DOCKET NO. 40-9027

LICENSE NO. SMC-1562

LICENSEE: CABOT PERFORMANCE MATERIALS, REVERE, PA

SUBJECT: SAFETY EVALUATION REPORT, SITE
DECOMMISSIONING PLAN, AND RADIOLOGICAL
ASSESSMENT, DATED MAY 24, 2001

Figure 1. Generalized conceptual model used in the Cabot-Revere assessment.

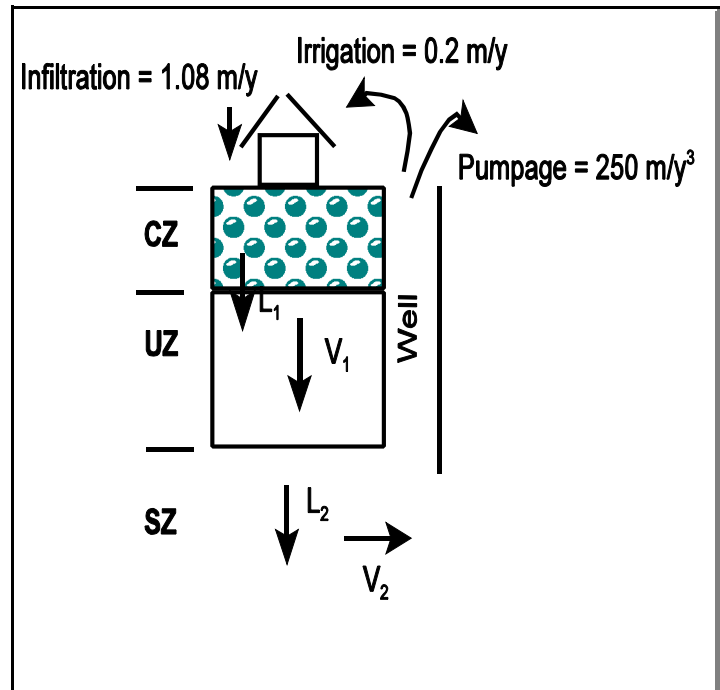
It should be noted that a default irrigation rate of 0.2 m/yr (0.7 ft/yr) was used in the analysis, although the licensee only assumed irrigation as part of its residential gardener scenario.

Based on regional information, the unsaturated zone is believed to be roughly 20 m (66 ft) thick; however, for the assessment, nominal credit is taken for the possible hold-up of contaminants migrating through the unsaturated zone. This is reflected by the small unsaturated zone thickness [0.01 m (0.03 ft)] assumed for the analysis. Staff believes that this adds conservatism to the calculated doses for the water-dependent pathways.
